RE: REQUEST UNDER SECTION 369 OF SPA FOR PERMISSIBLE CHANGE TO EXISTING APPROVAL FOR RECONFIGURING A LOT AND MATERIAL CHANGE OF USE (MULTI-UNIT HOUSING) AT 24 MUDLO STREET, PORT DOUGLAS, MORE PARTICULARLY DESCRIBED AS LOT 60 ON PTD20911

The following revised drawings are included for reference as **Attachment 2**:

Revised Plans

MUDLO STREET VILLAS

FLOOR PLAN - LOWER

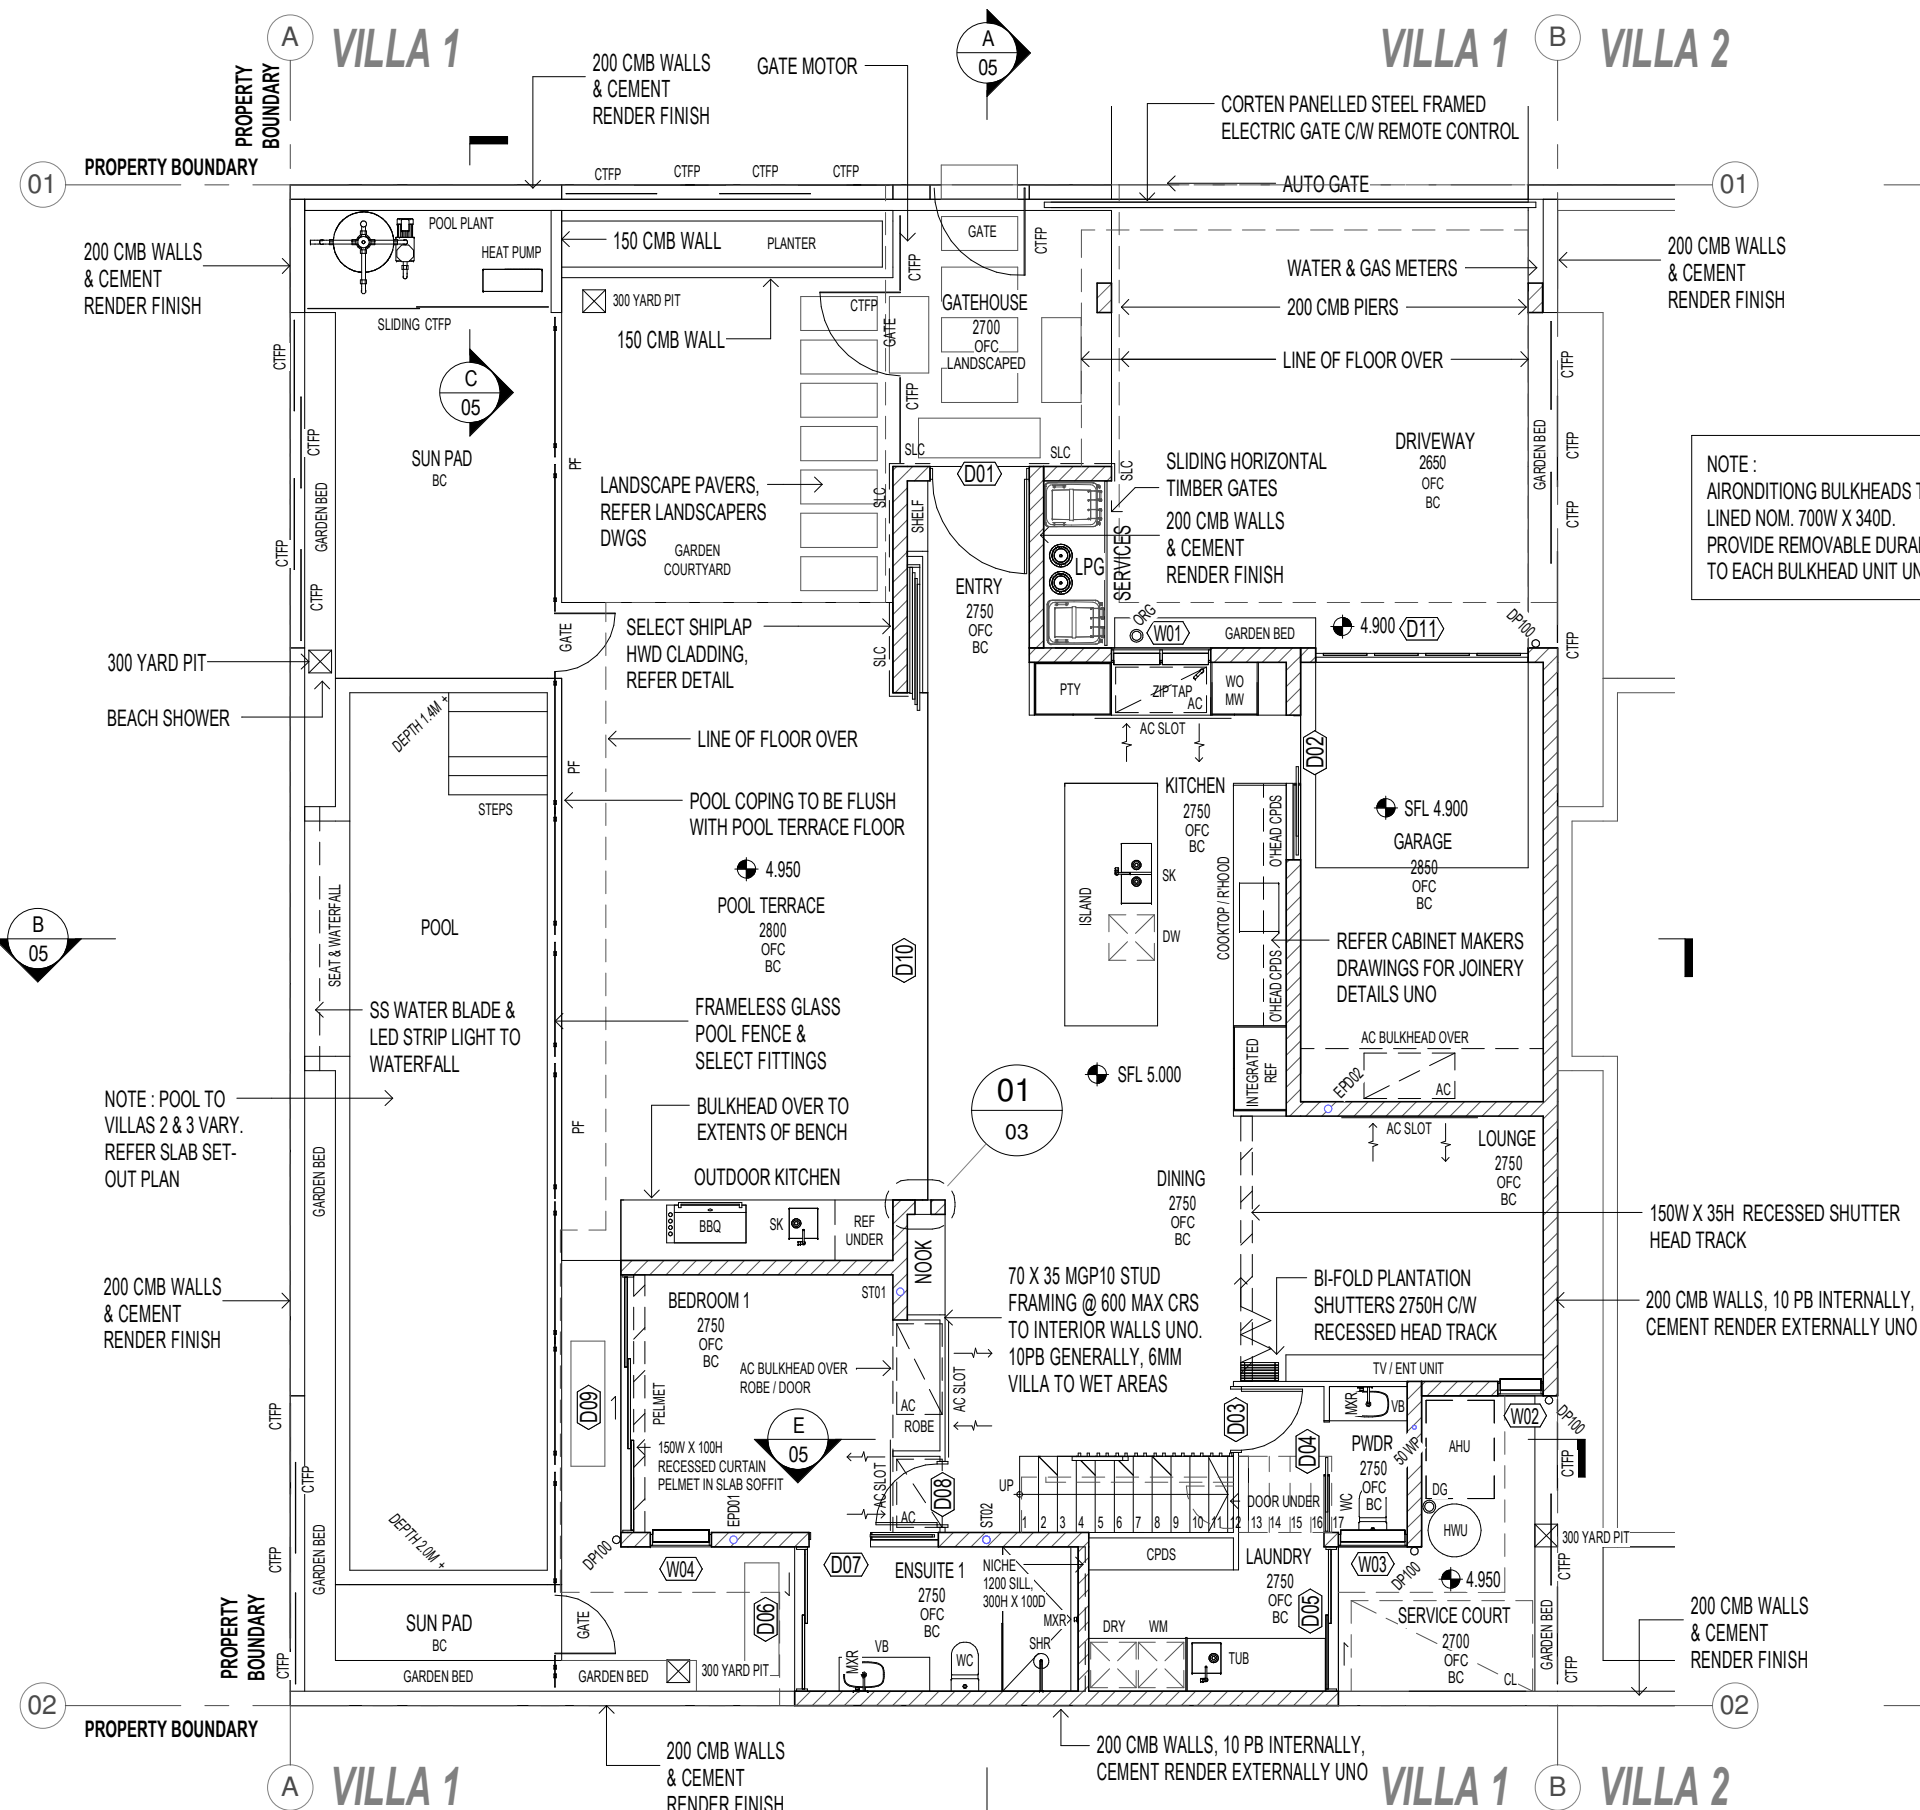
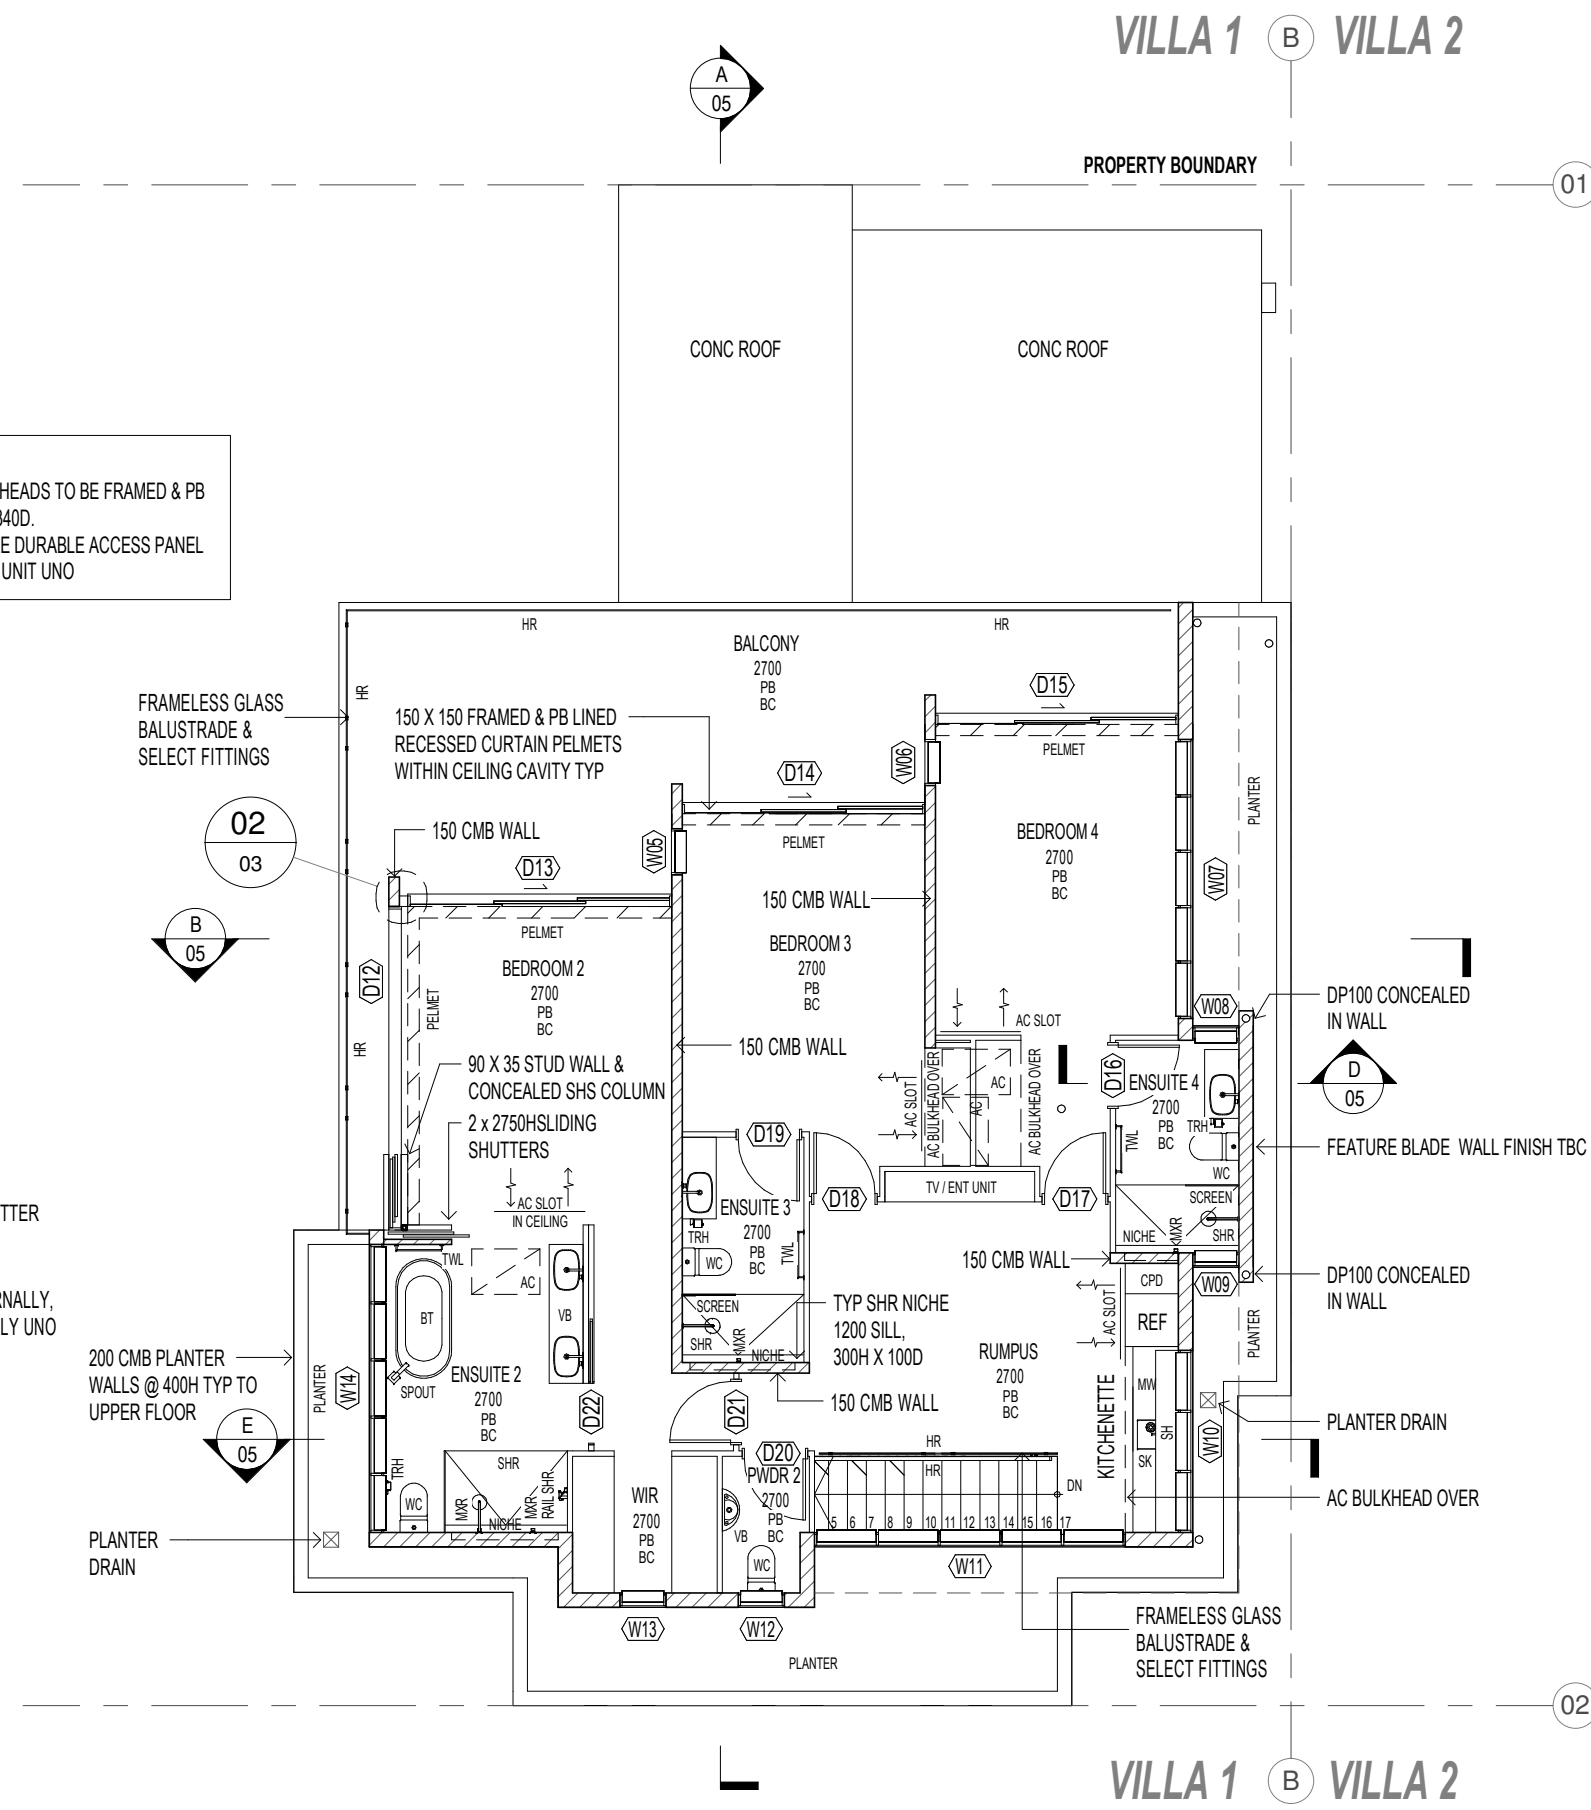
- Site Plan – Sheet 0
- Floor Plans – Sheet 3
- Elevations – Sheet 4
- Area Plan Site Cover – Sheet 5
- Street-View Renders.

As noted above, this submission seeks changes to the proposal to include a roof structure over the proposed parking areas for each dwelling. This change has come about following market feedback that the lack of undercover car parking is a concern.

Taking the above into account, the applicant is proposing a high-quality, visually appealing concrete roof structure, embellished with vine-type vegetation. As is evidenced by the Street View Renders, the change blends in seamlessly with the existing approved built form and continues to achieve a highly appropriate streetscape aesthetic.
